Subject: Notification of a Class 1 Permit Modification to the Hazardous Waste Facility Permit, Permit Number: NM4890139088-TSDF

- Correct Figure B1-1; and
- Correct Inconsistencies Regarding Headspace Gas Sampling for Thermally Treated Waste.

**Waste Isolation Pilot Plant
Carlsbad, New Mexico**

WIPP HWFP #NM4890139088-TSDF

Figure B1-1
 Headspace Gas Drum Age Criteria Sampling Scenario Selection Process

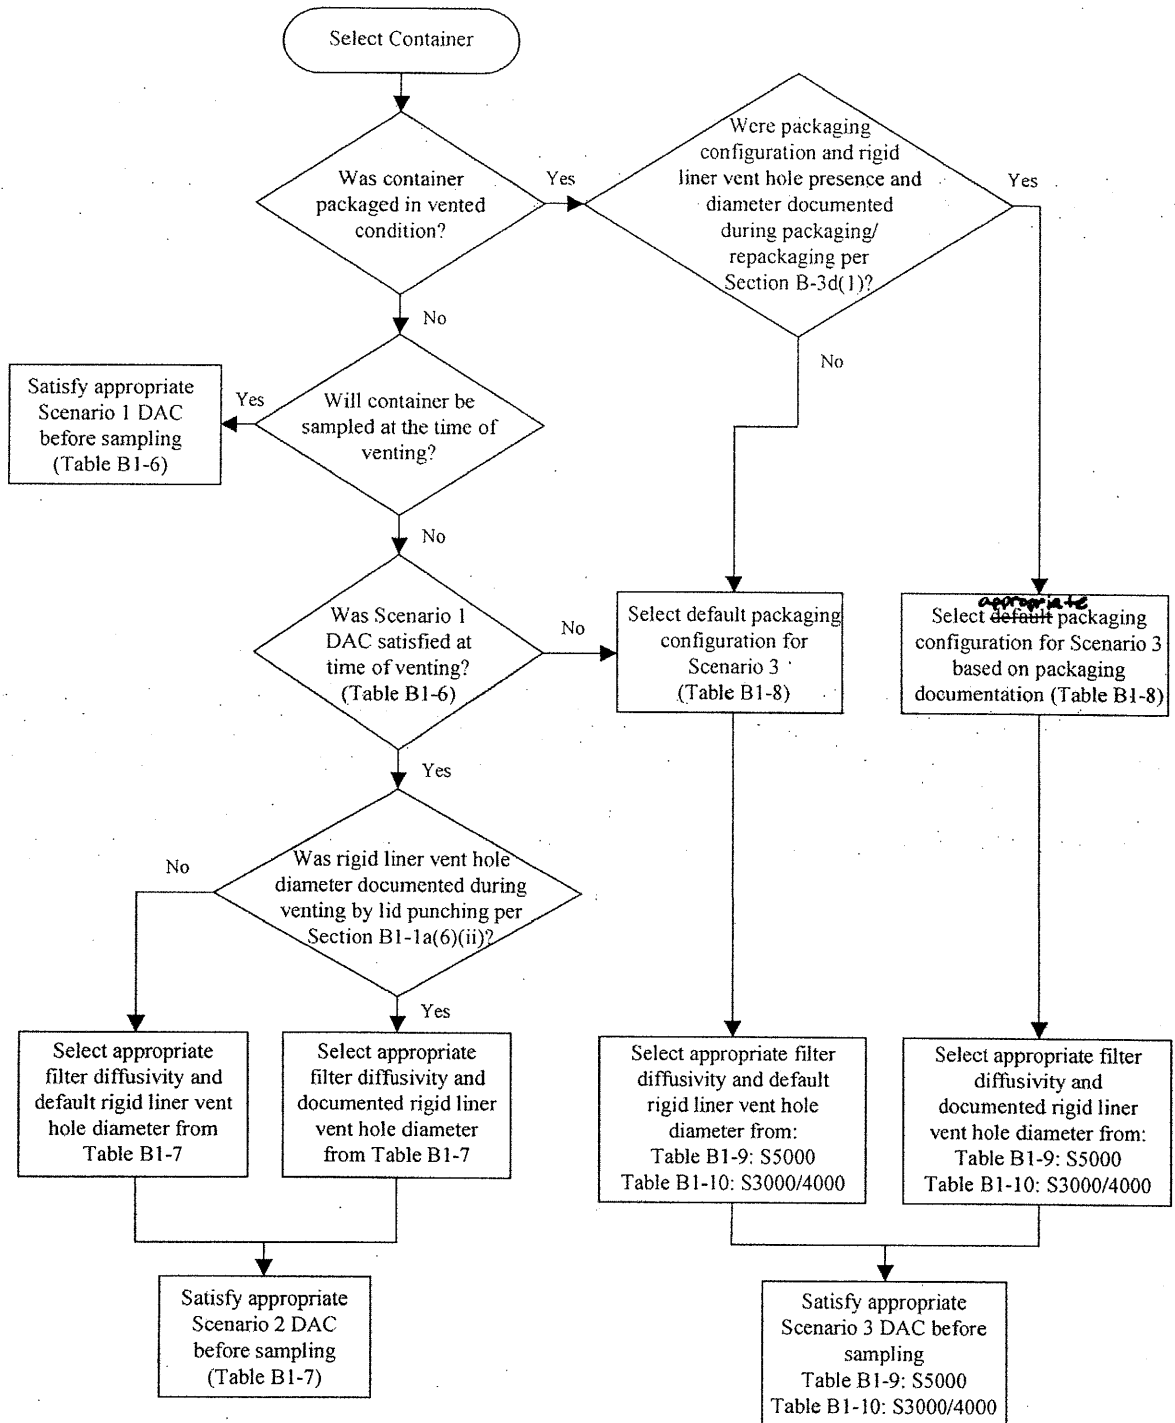
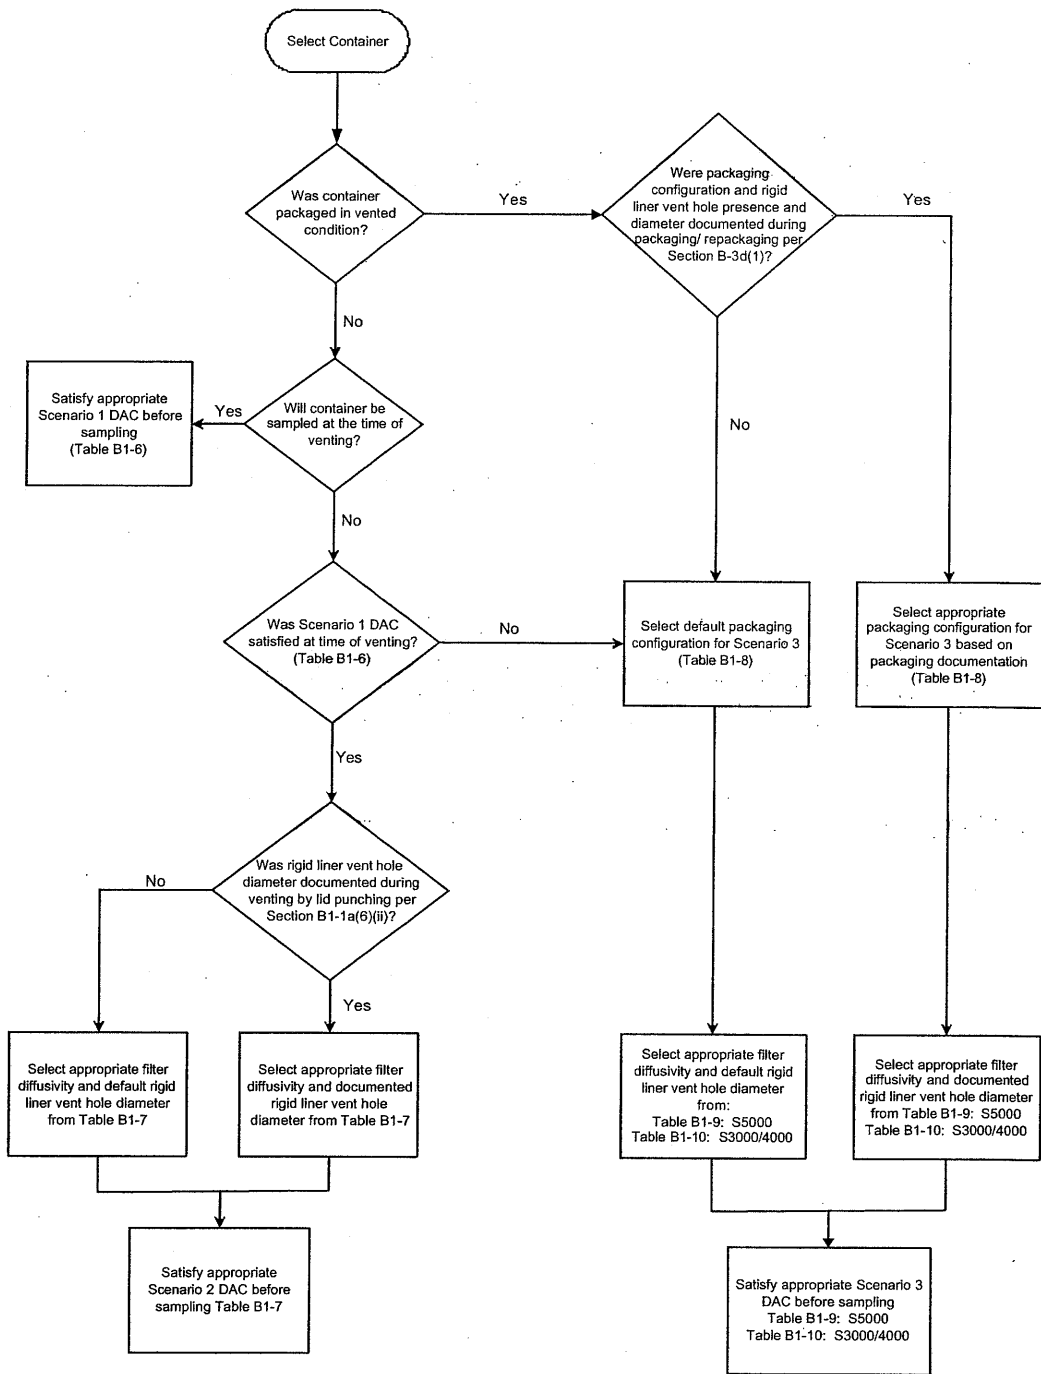
During the comment period for the proposed Drum Age Criteria (**DAC**) permit modification, a comment was submitted to the New Mexico Environment Department (**NMED**) by the Environmental Evaluation Group (**EEG**) indicating that the language in the logic boxes in Figure B1-1 was inconsistent with the language in the text of the proposed modification.

The Proposed Draft Permit dated August 26, 2002, and the final Order issued by the Secretary of the NMED on December 31, 2002, did not include the correction to Figure B1-1. In subsequent discussions with the NMED, it was determined that Figure B1-1 was not corrected due to an inadvertent oversight.

The correction needed is to delete the word "default" and replace it with the word "appropriate" in the box that currently states "Select default packaging configuration for Scenario 3 based on packaging documentation (Table B1-8)"

- a. 1. Revised Figure B1-1 (includes both a redline strikeout version and a "clean" version to incorporate into the permit).
